January 10, 2025

RE: No Further Action Determination
for Oregon Ballet in Portland
LUST #26-13-1039

The Oregon Department of Environmental Quality (DEQ) has completed a review of the available information for the Oregon Ballet property, including the closure report entitled, *Technical Memorandum*, dated January 29, 2024, which was submitted to DEQ by Equant on your behalf. The Oregon Ballet address is 6250 SW Capitol Highway in Portland, Tax Lot1S1E16CD 3400.

Figure 3
Probe Boring and Sub-Slab Sample Locations
Portland Ballet Site
Site Investigation
July 2023

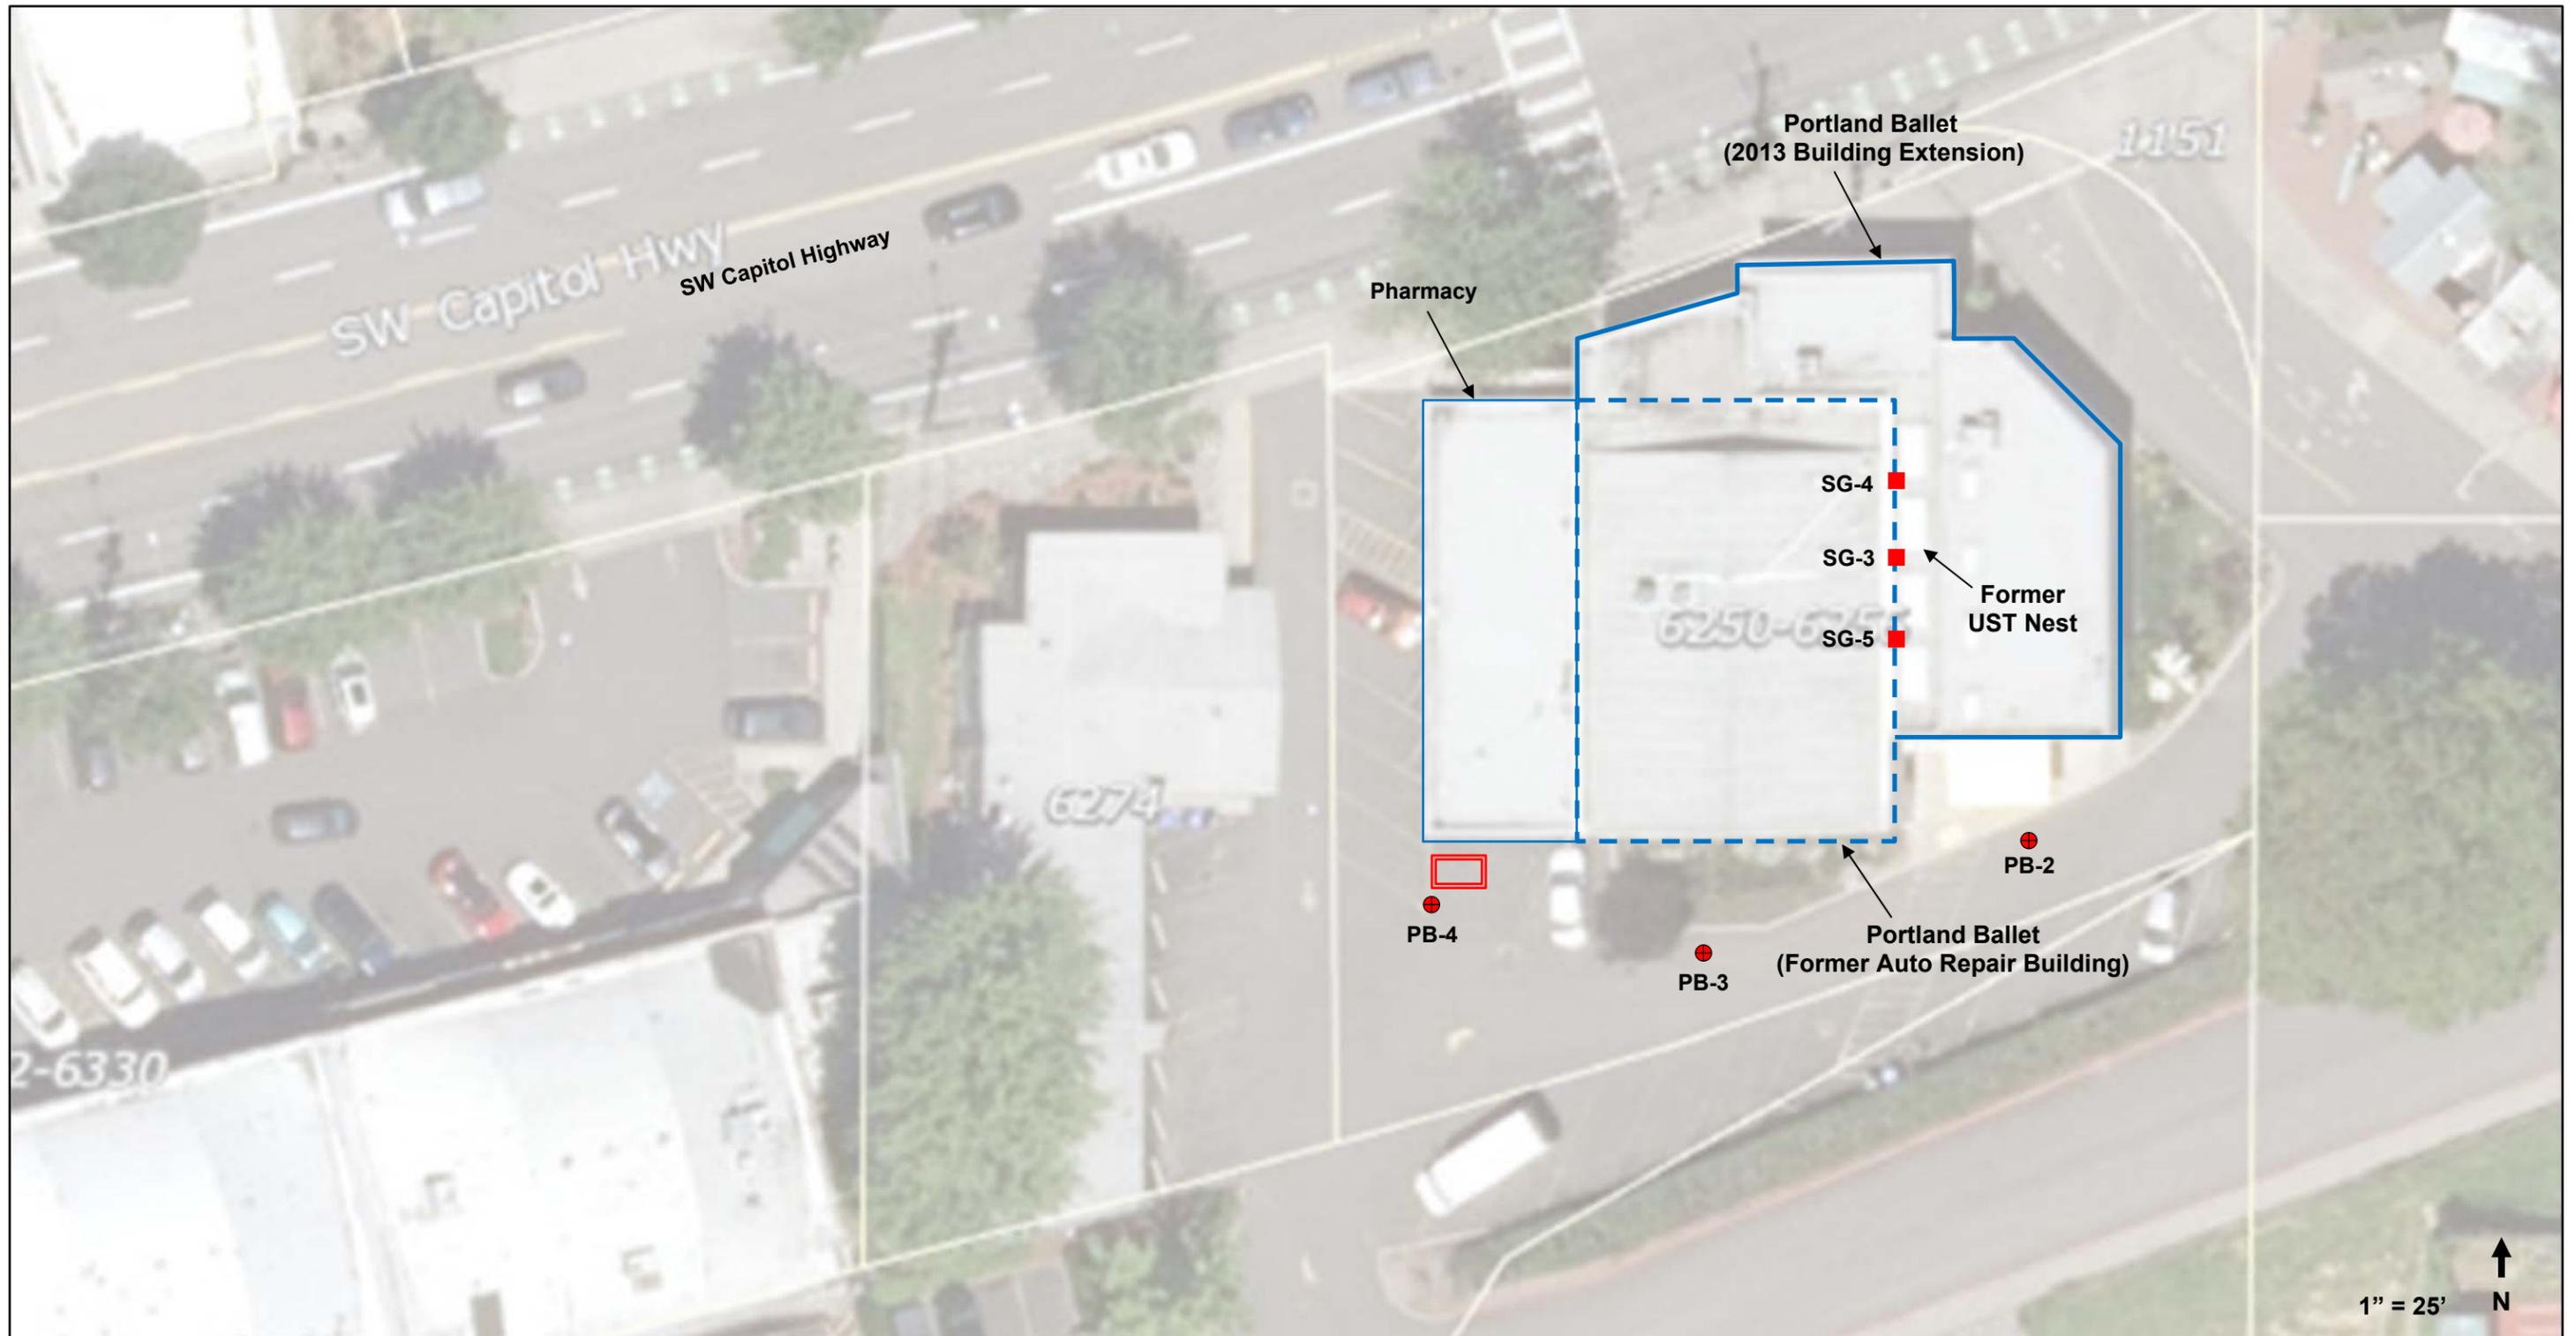
- In 2023, three borings and three soil gas points were installed (Figure 3). During this investigation, no soil contamination was noted. In groundwater, up to 2,620 parts per billion (ppb) of gasoline and 1,650 ppb of diesel, and 14,500 ppb of heavy oil were detected from temporary well point PB-3. Sheen was noted on groundwater in borings PB-3 and PB-4. Soils consist of low permeable silts and clays.

- In soil gas, up to 1,300 micrograms per meter cubed ($\mu\text{g}/\text{m}^3$) of gasoline were detected in each of SG-3 and SG-4. These concentrations are below DEQ's 2023 soil vapor risk-based concentrations (RBCs). Some volatile organic compounds were detected at levels below RBCs. Tables 1-3 includes soil, groundwater, and soil gas results.

DEQ has determined that investigations and remedial action to address environmental contamination at Oregon Ballet is complete, and no further action is required. This determination is a result of our evaluation and judgment based on the DEQ regulations and the facts as we now understand them including the following:

Based on the available information, soil, soil gas, and groundwater conditions at Oregon Ballet are currently protective of public health and the environment in accordance with Oregon Administrative Rules 340-122-0205 through 340-122-0360. The site requires no further action unless new or previously undisclosed information becomes available, or there are changes in site development or land and water uses, or more contamination is discovered. DEQ has updated the Your DEQ Online (YDO) database to reflect this decision.
